04. DESIGN PROPOSAL

PROPOSED SCHEME, SW & NE ELEVATIONS

PROPOSED SCHEME, SECTIONS AA & BB

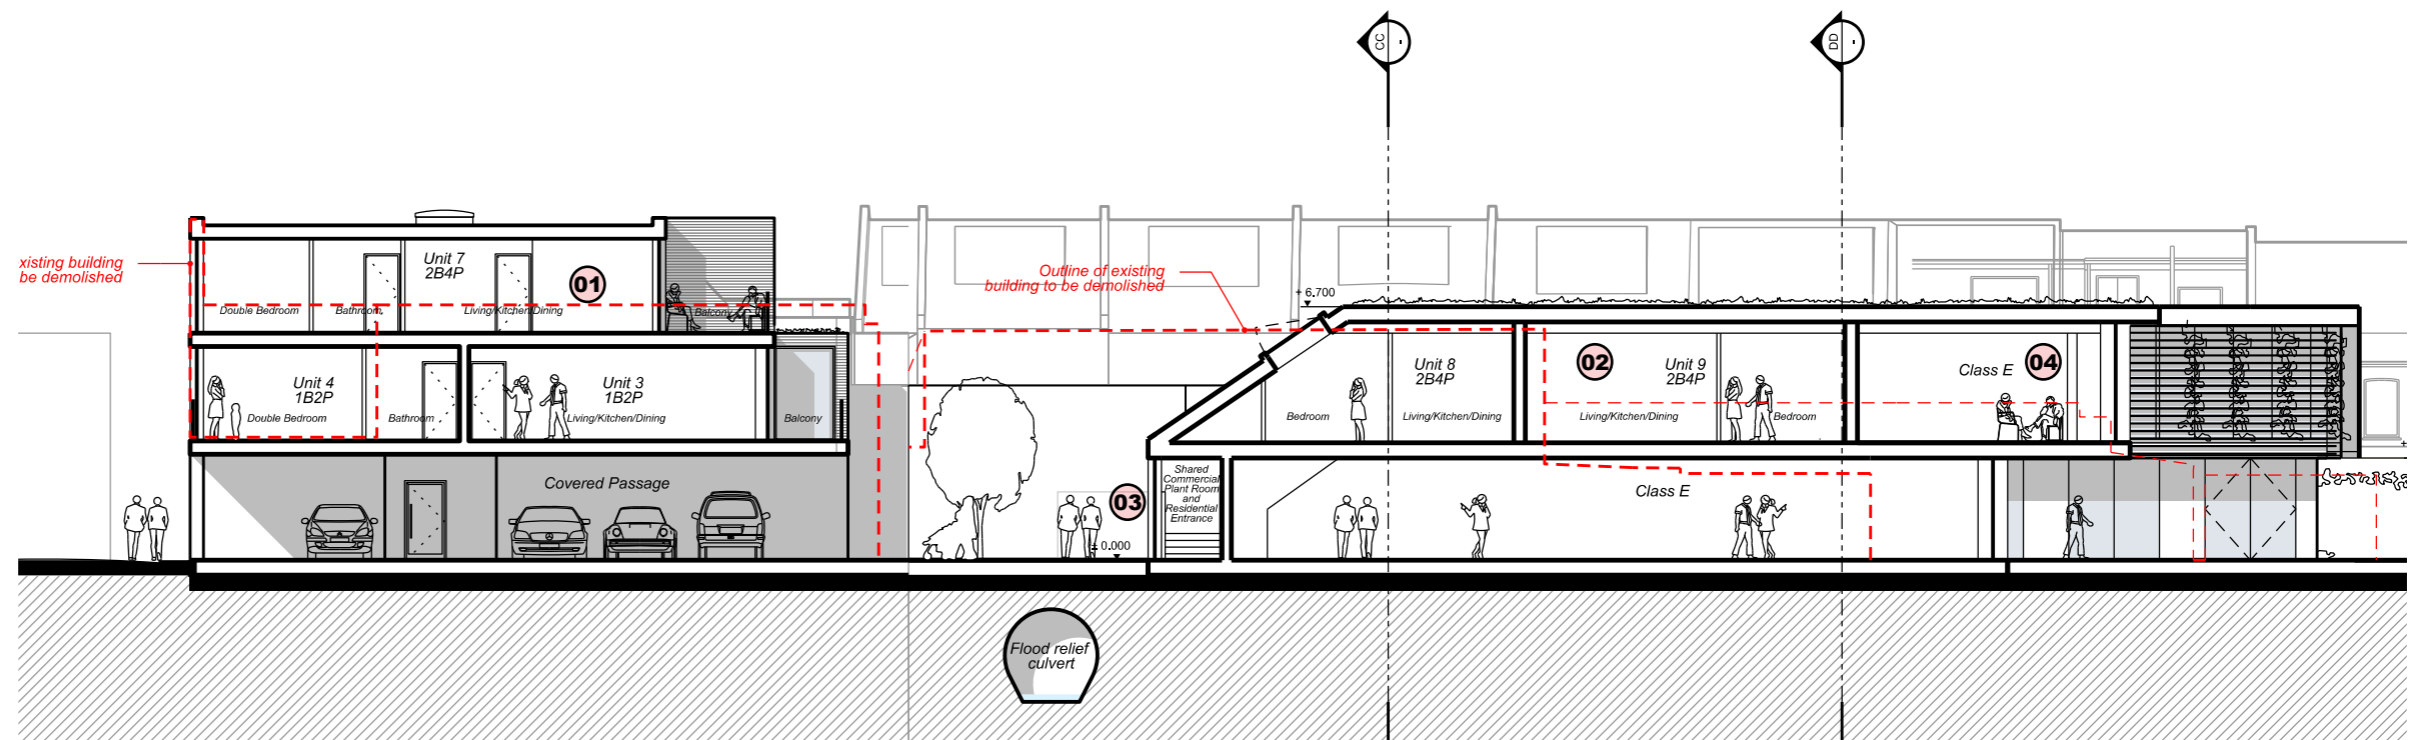
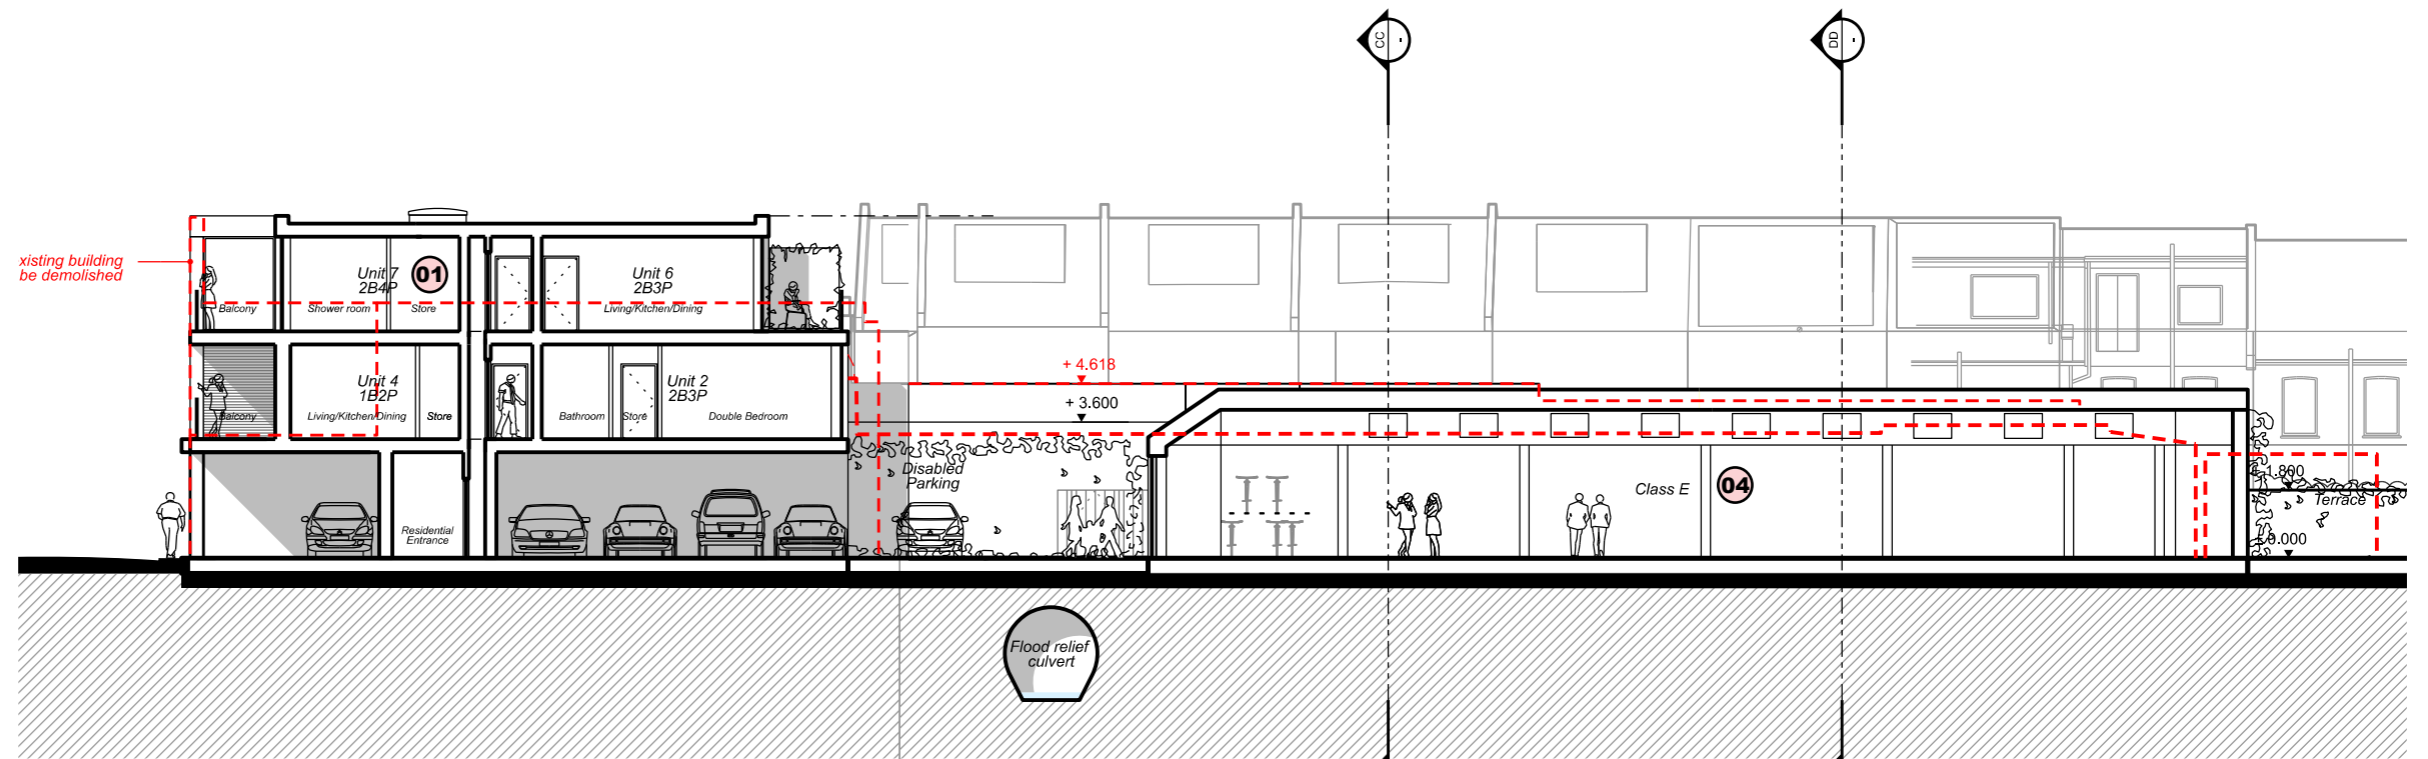
01 Layout of units improved in order to comply with fire regulation.

02 Part of the commercial space to be used as residential. A total of 2 x 2B4P units.

03 New shared entrance and stair core for access to commercial plant room and residential units at first level.

04 Commercial layout amended including plant room.

PROPOSED SCHEME, SECTIONS CC & DD

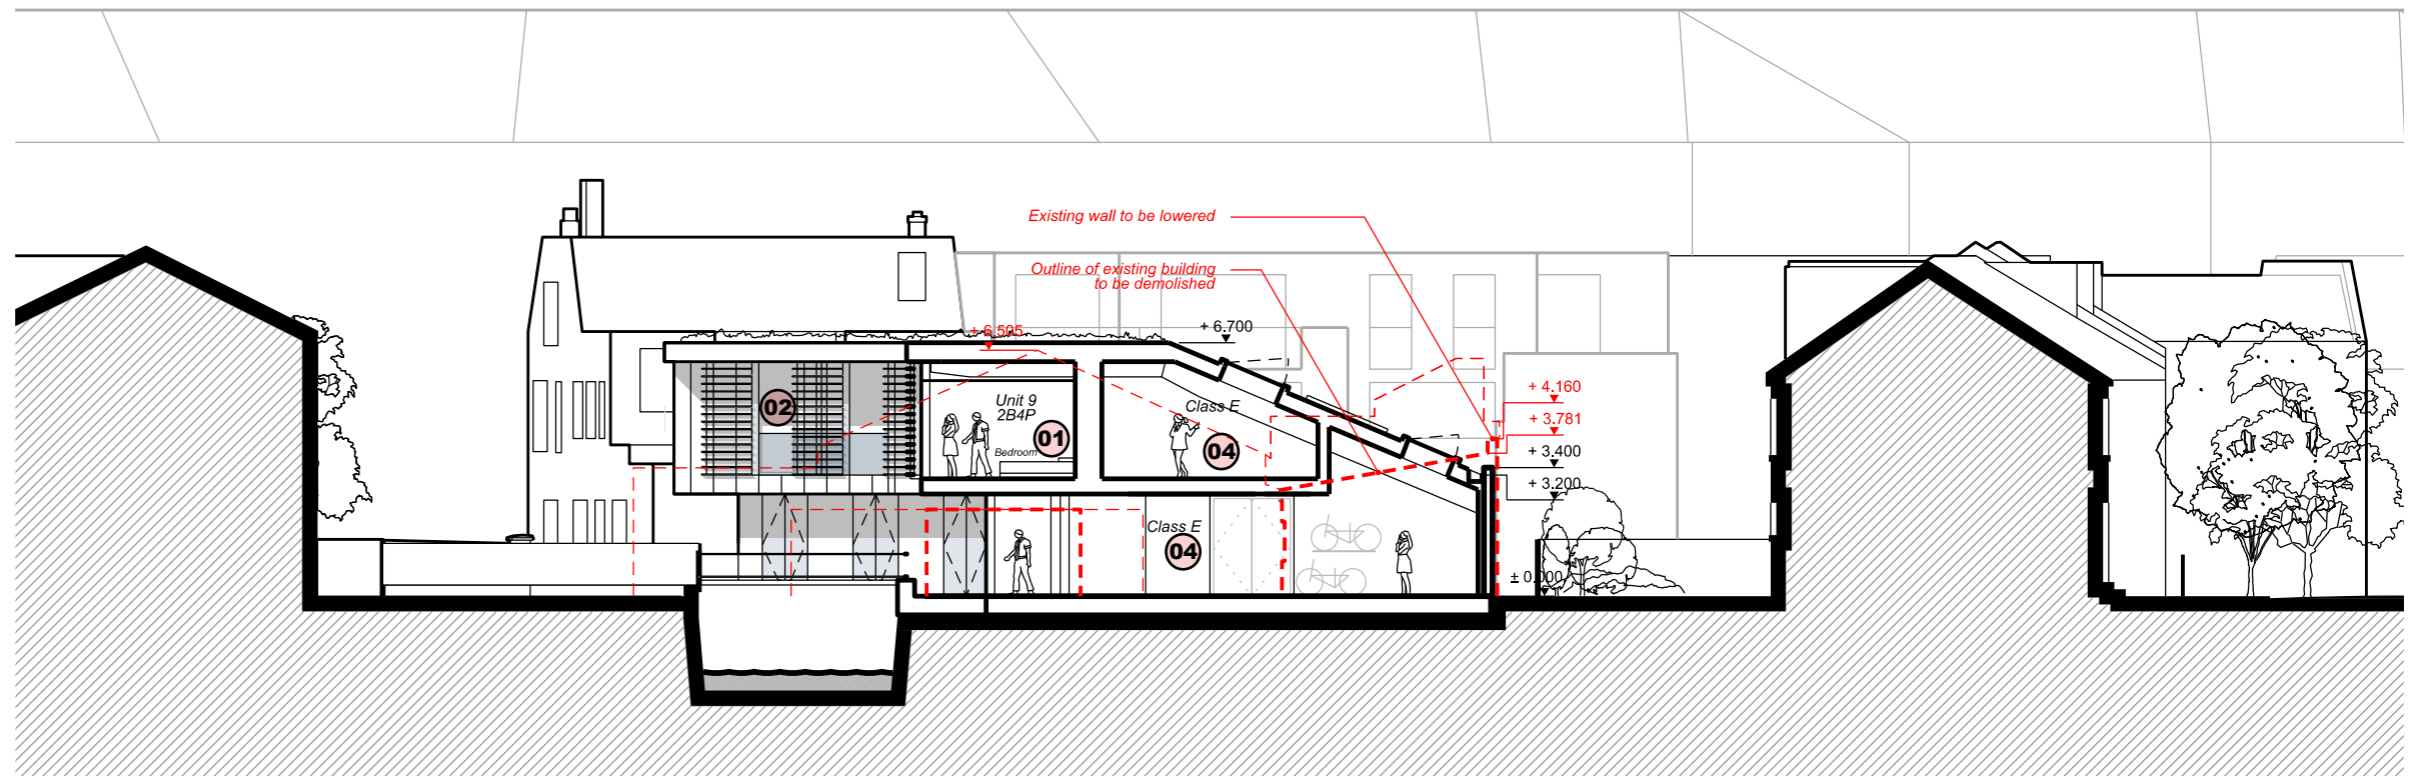
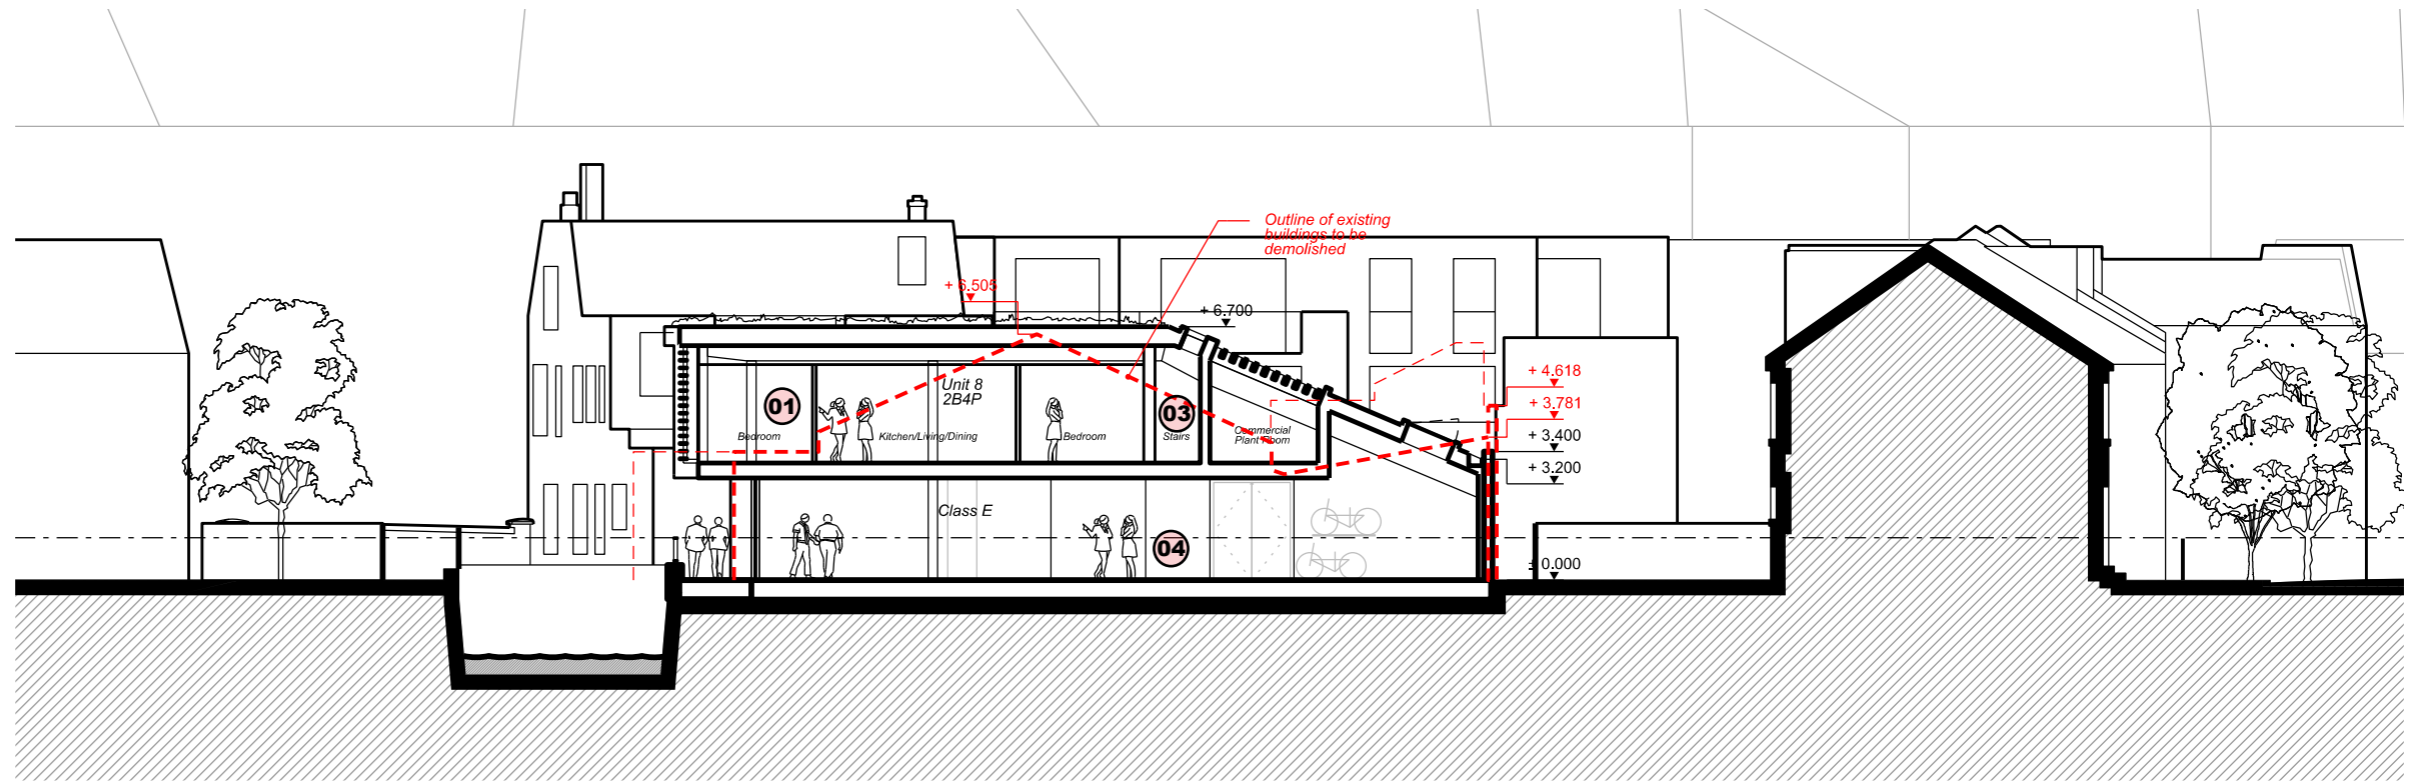
01 Part of the commercial space to be used as residential. A total of 2 x 2B4P units.

02 Glass balustrades in balconies for residential units at first level.

03 New shared entrance and stair core for access to commercial plant room and residential units at first level.

04 Commercial layout amended including plant room.
